STATEMENT OF CHARLES STOKES

1. My name is Charles Stokes. I am providing this statement, at the request of Mr. Joel Reynolds, for his submission to the Atomic Safety and Licensing Appeal Board. My statement rebuts the Pacific Gas and Electric Company (PGandE) defenses of the seismic design review as submitted to the Appeal Board as an attachment to an affidavit of R.C. Anderson, M.J. Jacobson, M.E. Leppke and L.E. Shipley dated March 5, 1984.

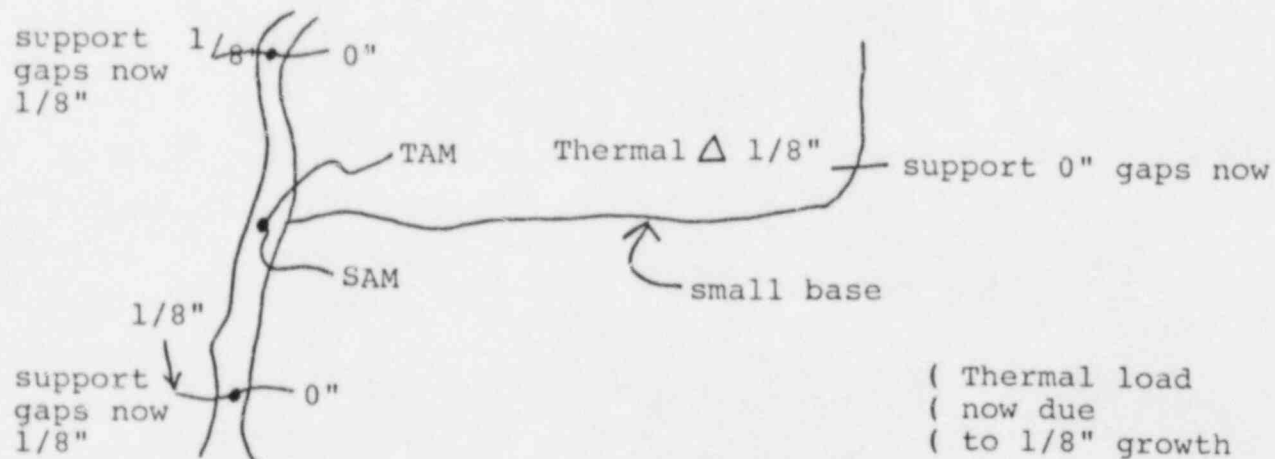
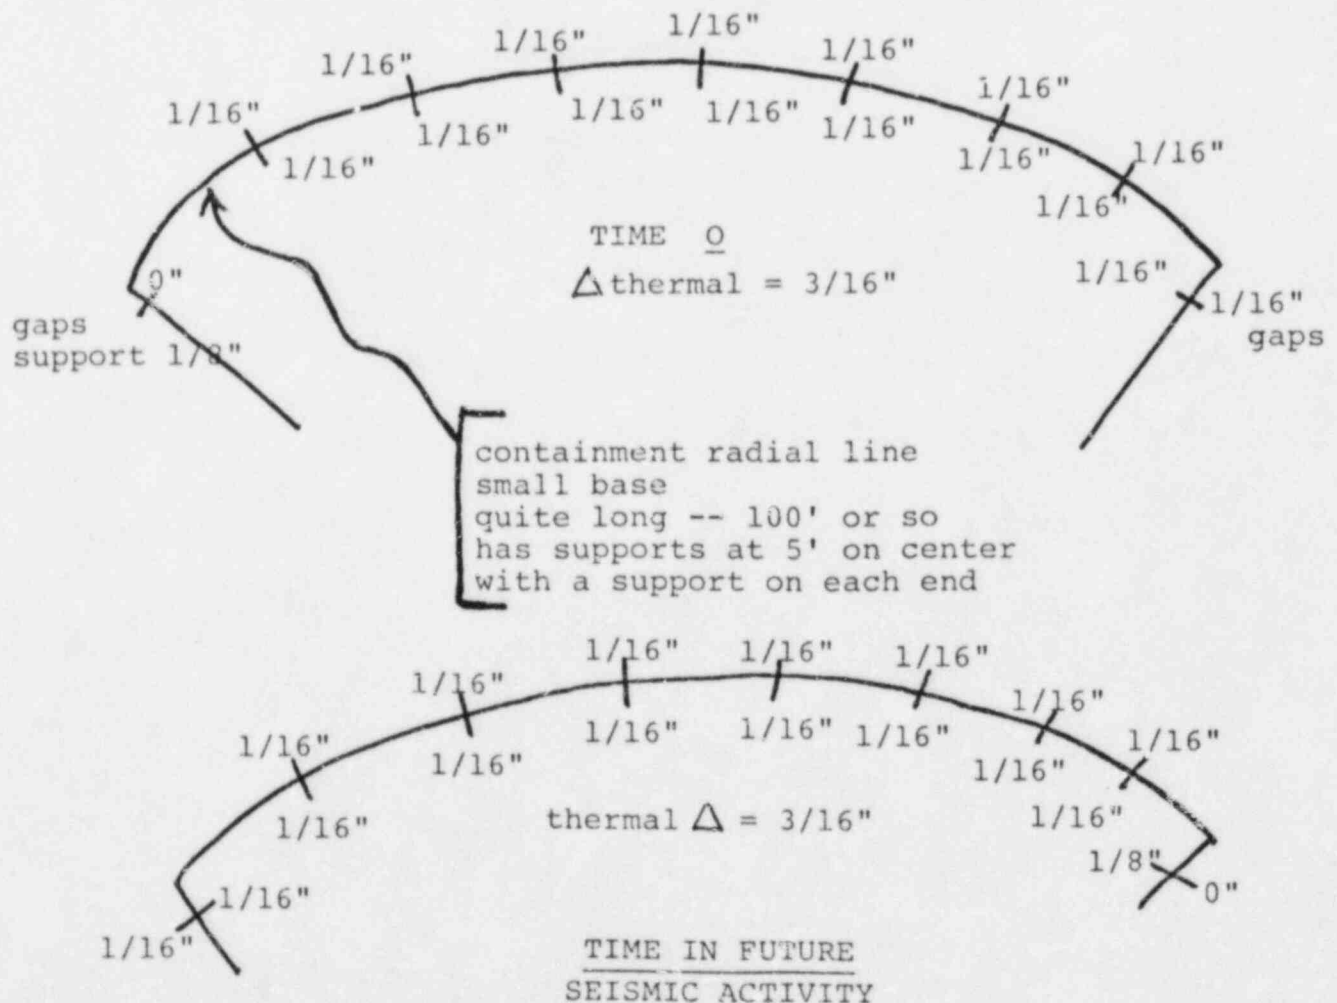
7. From PGandE's response, it seems obvious that they have reviewed thermal effects with blinders on. In a plant subject to seismic excitation, the only reliable anchors are those such as wall penetrations (which can vibrate depending on location) and anchors attached to walls, floors, or ceiling core or steel (they, too, can vibrate depending on fixity of structure). In effect, no anchor should be assumed completely in reduction of thermal load. For example, a large bore pipe is considered an anchor due to relative size. However, unless the large pipe itself is anchored close to the small pipe branch line, its location cannot be relied on over the life of the plant in establishing the thermal gaps to reduce loadings to other supports. To illustrate:

SAM (Seismic Anchor Movement)

TAM (Thermal Anchor Movement)

Time in Future
Seismic Disturbance

8. Depending on total conditions, use of gap may not be valid. Either it should not have been used to relieve load to small bore supports, or after every seismic disturbance these supports subject to increased load should be reviewed for gap and movement changes in location of TAM of large bore line. Also a similar effect occurs on a small bore line with a restraint on each end. If this line is quite long and the hold line is shifted due to seismic activity, the support at each end could be subjected to larger than designed-for loads. Example:

9. This may not be the worst case scenario. At time 0 the plant is cold. As it heats up, the line expands uniformly. This is because friction on the supports grows from the middle of the radial line out and produces balanced loading on each side of the center point until one end grows enough to encounter a restraint. The first end to hit is the right side after 1/16" growth; then this support in effect pushes or is pushed against by all friction loads on all supports as the line grows in the other direction of freedom. Time 0 on the right end is subjected to the sum of all friction force developed by internal supports. At some time in the future, during cold shut-down for refueling, a seismic disturbance occurs and the line shifts position. Expansion occurs as it did at Time 0, only now the left end is the restraint.

10. When gaps are used to relieve thermal load, there are certain requirements. I have never seen the load considered this way, with unequal placement or uncentered placement of the line in relation to gaps. The general assumption is that if there is 3/16" thermal expansion and there are a total of 3/16" gaps, then there is no thermal load to any support. This is not a conservative analysis, and I question whether or not the cases hypothesized above have been considered in the stress calculations and the resulting loads given to the support group.
